APPENDIX B

Information of Class II Permissive Change

EUT Type: Household Electric Oven
Model Name: LC389PC
FCC ID.: BEJD179NAA
Applicant: LG Electronics USA.

2. Contents of change(s): Main Board PCB layout and schematic changes

<Main PCB > : **EAX67927201**

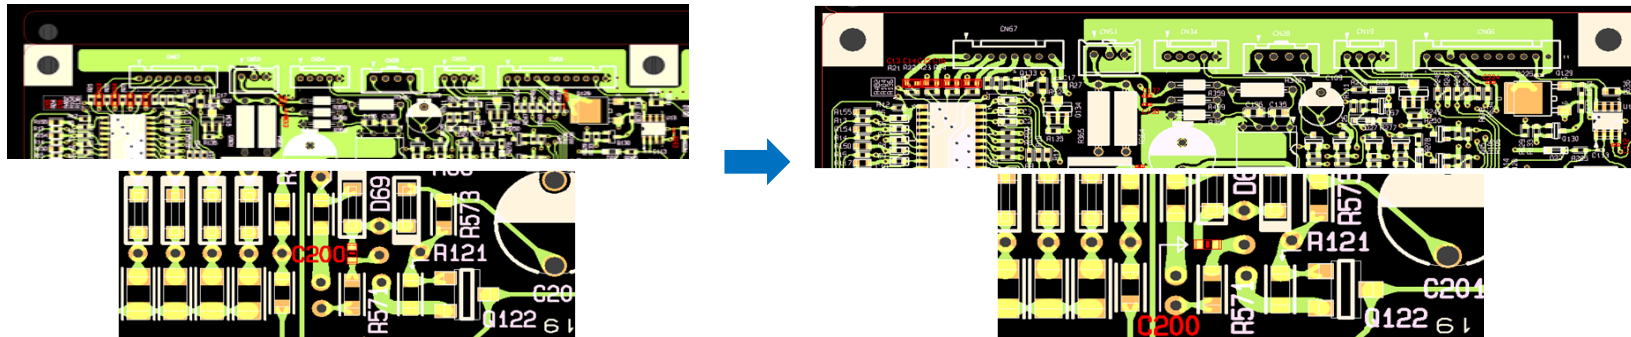
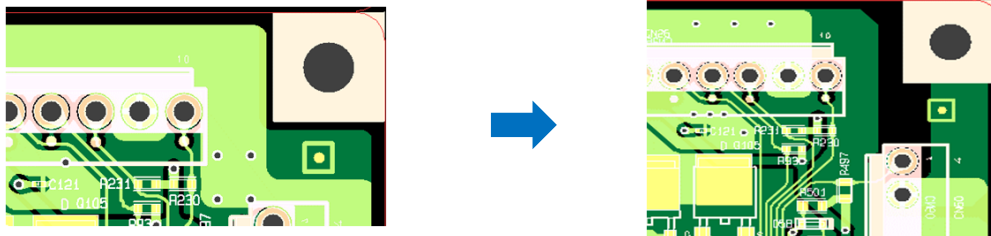
1. MLCC direction : vertical -> horizontal (C137,C138,C13,C14,C15,C16,C224,C112,C104,C200)

2. Connect PCB gnd pattern to earth gnd

3. Q104, Q106 : 2N7002(FET) -> KTC3875S(TR)

Add R167, R168 : 4.7Kohm

4. R160, R163 : 2Kohm -> 10Kohm
